APPLICATION NO.	FILING DATE	FIRST NAMED INVENTOR	ATTORNEY DOCKET NO.	CONFIRMATION NO.
10/771,846	02/03/2004	Olaf Muller	7100-X04-025CIP (NEW)	9733
27317 7590 05/02/2007 FLEIT KAIN GIBBONS GUTMAN BONGINI & BIANCO 21355 EAST DIXIE HIGHWAY SUITE 115 MIAMI, FL 33180			EXAMINER CULBRETH, ERIC D	
			ART UNIT 3616	PAPER NUMBER
			MAIL DATE 05/02/2007	DELIVERY MODE PAPER

Office Action Summary	Application No.		Applicant(s)	
	10/771,846		MULLER, OLAF	
	Examiner		Art Unit	
	Eric Culbreth		3616

Active safety steering column

Fig. 1

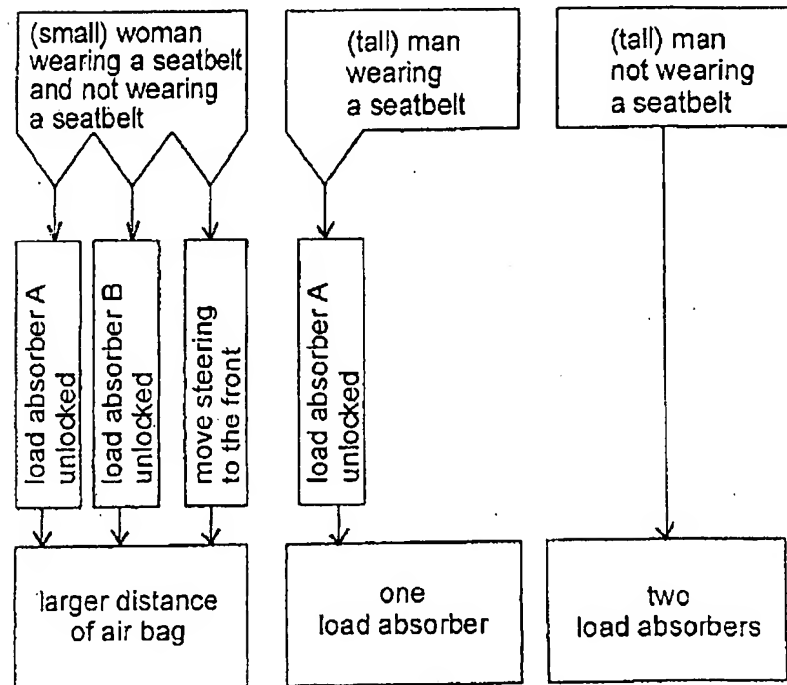
Approved

4/28/07
